TECHNICAL DOCUMENTATION CHANGE NOTICE

EK-OLN03-RM-CN1

LN03 PROGRAMMER REFERENCE MANUAL

EK-OLN03-RM-002

PAGE 114

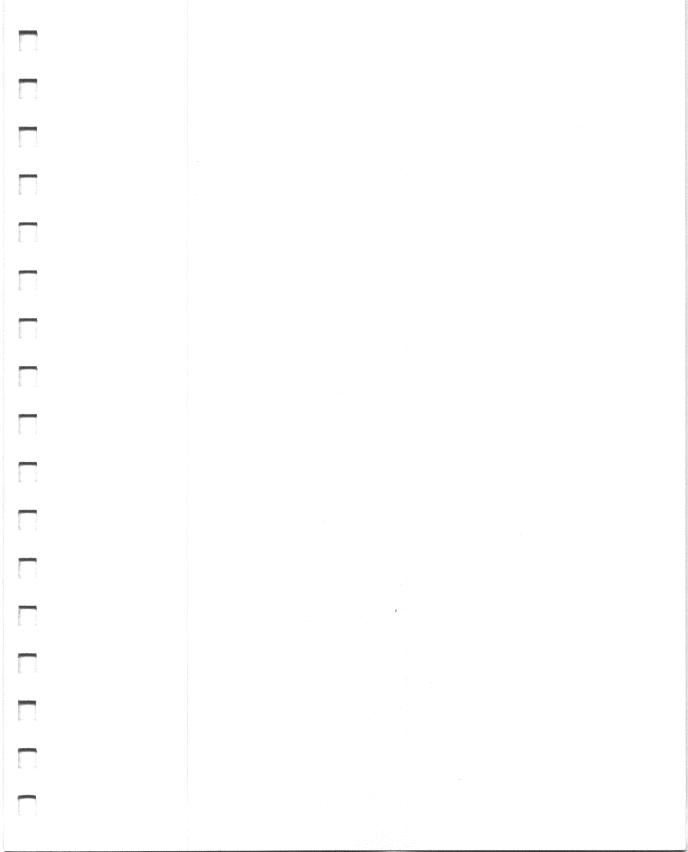
Add the following error code to the specific controller error codes listed in Table 5-6.

Pn	- 연락 ETPOP : 프로프트 등이 프로프리아 프로그램 제 기업을 보고 되는 것으로
115	Character lost, right margin exceeded.
